Primark Reading – Description of Planning Amendments

Reason For Change:

Internal photos of existing glazing and soffit following strip out

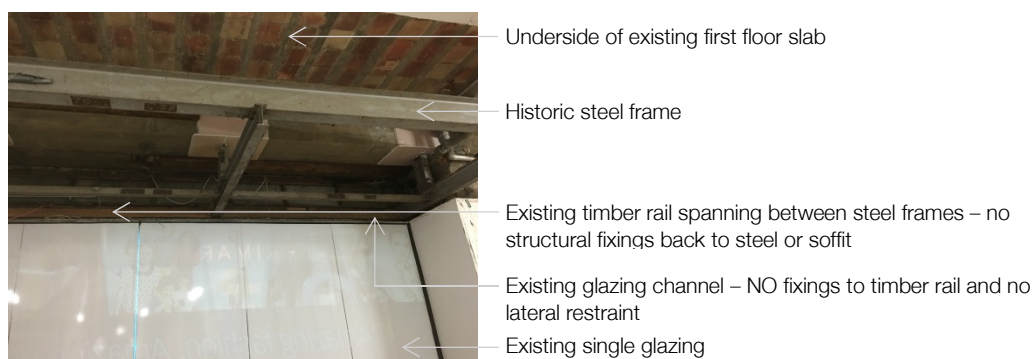
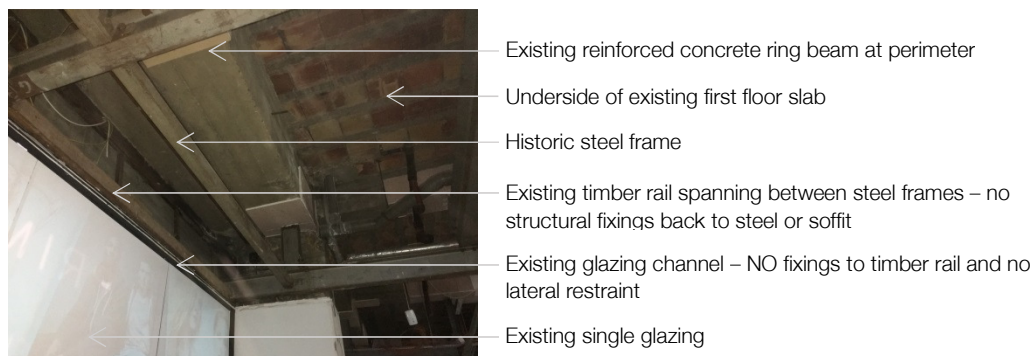
Once the existing suspended ceiling had been stripped out and the existing glazing framing had been exposed, it was apparent that the original installation was incomplete and unsafe. The glazing framing at the head was unrestrained and had no structural fixings back to the soffit to prevent lateral movement. Specialist sub-contractors have reviewed the existing installation and stated that it will not be possible to warrant or safely carry out remedial works to the existing. As such the installation has been deemed unsafe and has now been temporarily supported using timber framework. See below summary of observations of the existing construction.

1. The glazing head channel is intermittently fixed to a horizontal timber frame comprising of 50 x 50mm timber struts at approximately 550mm centres.
2. A horizontal timber ladder frame is fixed back to the underside of the concrete down stand beam.

3. External metal cladding panel is fixed to the external face timber ladder frame.
4. No, breather membrane, sheathing or backing board no sub frame with insulation to support the metal cladding no vapour barrier or EDPM.

5. No flashings dressed into or around the existing columns and structure to prevent ingress of water.
6. Large span glazing panels are not tied back to the upstand and there is no structural, lateral support to the glazing.

7. Large span glazing is supported in a single frame with silicone joints, this is non compliant.
8. Further along Cheapside the glass panels have intermediate structural glass fins but these are supported from timber framework rather than fixed back to the floor slab

- Construct an external hoarding along both the Friar Street and Cheapside elevations. See hoarding proposal below
- Demolish the existing glazing and strip out all associated framing redundant framework and connections to structure

- Strip out the internal steel frame (as described above)
- Strip out historic timber framing internally and prepare opening
- Install new double glazed framework – mullions to span from structural blockwork upstand to the underside of the reinforced concrete downstand above. The proposed system is Raico Therm+ 56 Curtain Wall System. Framing to receive powdercoated finish to match existing frame.

- Install carrier tray at high level between mullions for fixing of new insulation and weatherproofing
- Install new powdercoated, insulated stall riser cladding and cill below the new glazing. Finish to match existing frame

- New glazing to comprise x1 pane of toughened, glass and x1 pane of toughened, laminated, glass. Whole unit to achieve 1.8w/Km² to comply with Building Regulations

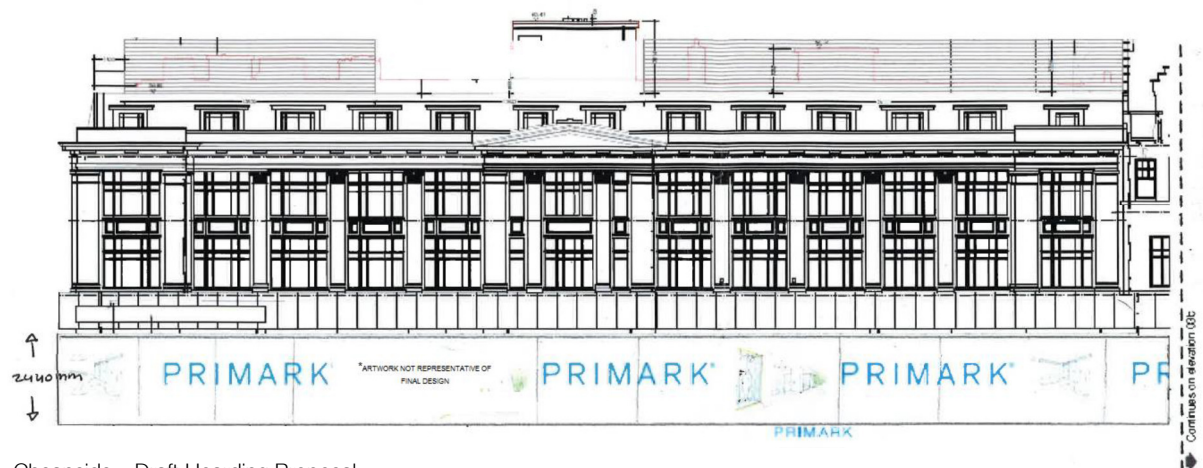
Ground Floor Glazing – Typical Window Bay – MS 630

- New detail drawing showing 1:20 detailed elevation, vertical section and sectional plan through a typical section of new glazing within an existing opening on the Cheapside elevation of the building.
